VERMONT YANKEE NUCLEAR POWER CORPORATION

March 29, 2001
BVY 01-27

**Subject: Vermont Yankee Nuclear Power Station
License No. DPR-28 (Docket No. 50-271)
Supplement to Technical Specification Proposed Change No. 244**

Supplement to Proposed Technical Specification Change No. 244

FIGURE 3.6.1

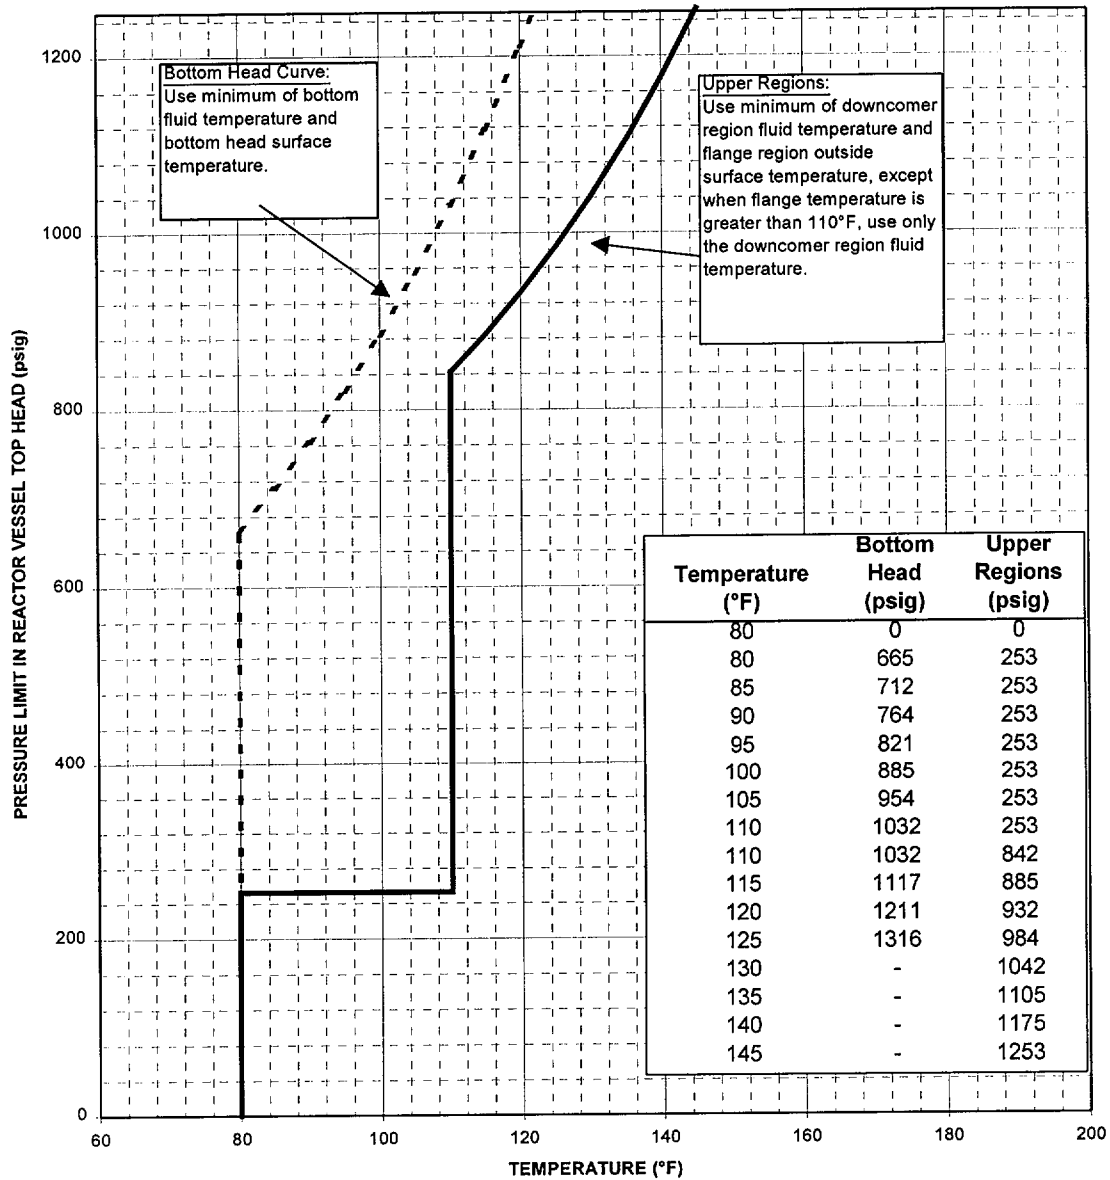
The operating portion of Cycle 23 is currently scheduled to end in April of 2004. Attached to this letter are the re-typed Figures which identify that the curves are "Valid Through End of Cycle 23." It is noted that these Figures continue to be based upon a conservative ART_{NDT} that will bound the affect of fluence on reactor materials through 4.46E8 MWH(T), which is the equivalent of 32 effective full power years (EFPY). It is estimated that at the end of Cycle 23, the reactor will have experienced equal to or less than 25.5 EFPY's.

40°F/hr Heatup/Cooldown Limit
Valid Through End of Cycle 23

FIGURE 3.6.2

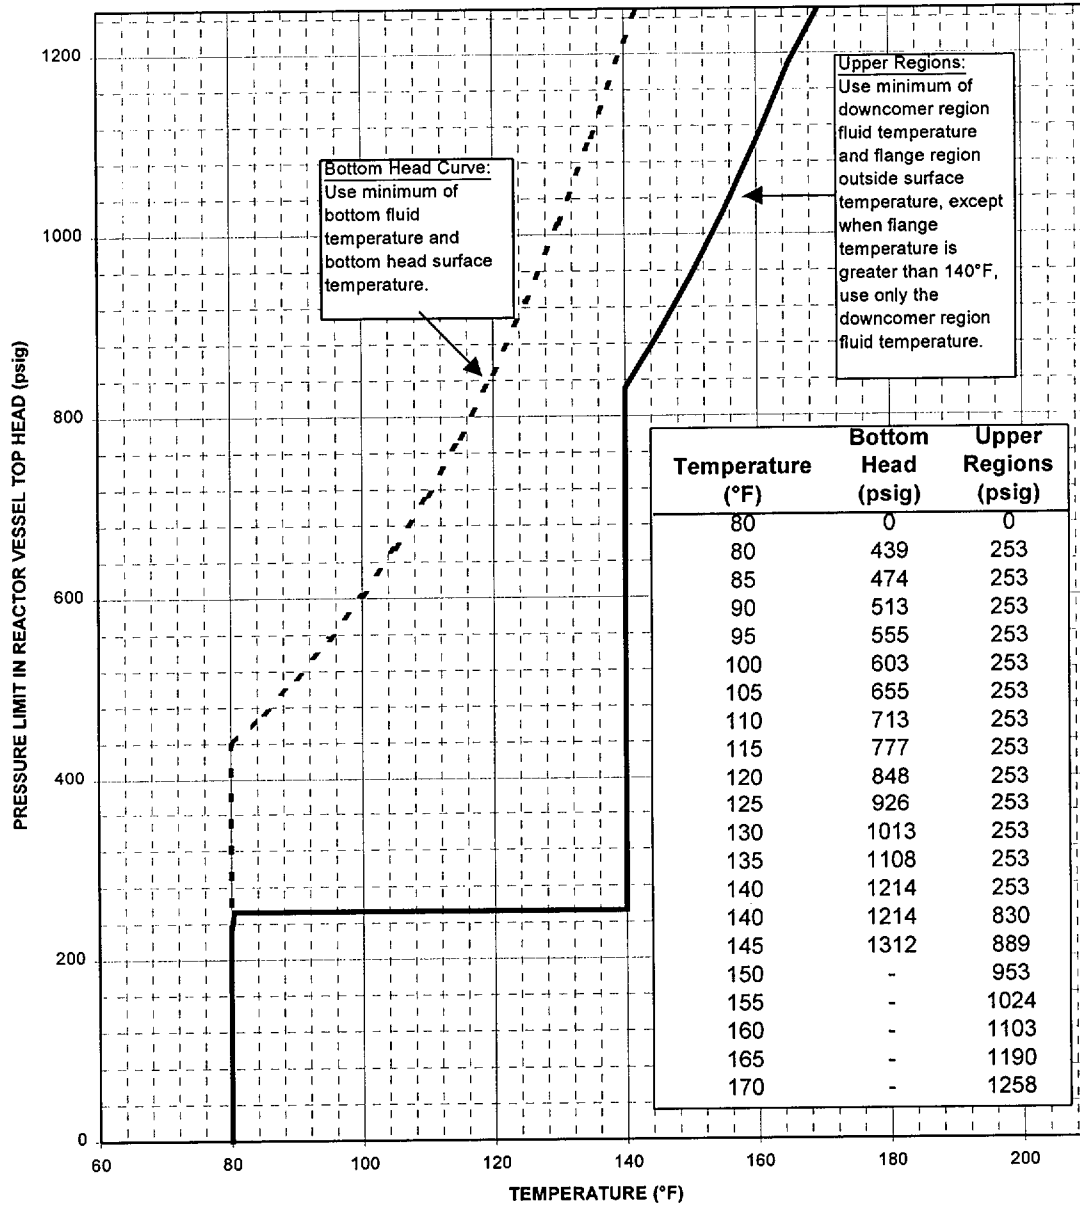
100°F/hr Heatup/Cooldown Limit
Valid Through End of Cycle 23
